Interactive comment on “Quantifying the impacts of human water use and climate variations on recent drying of Lake Urmia basin: the value of different sets of spaceborne and in-situ data for calibrating a hydrological model” by Seyed-Mohammad Hosseini-Moghari et al.

S. Khatami

Received and published: 3 November 2018

Fig. 1. Annual inflow to the lake

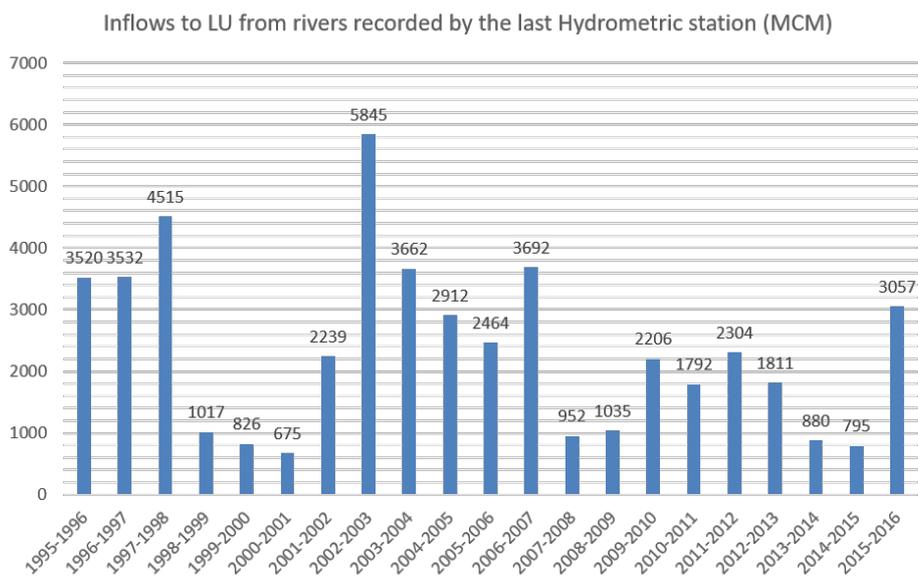
For instance, annual inflows to the lake are highly variable during this period (see the supplement figure), which you also used for calibrating the model. Given such degree of variability, the modelling results are likely sensitive to this variable, and it is important to use the entire time period.
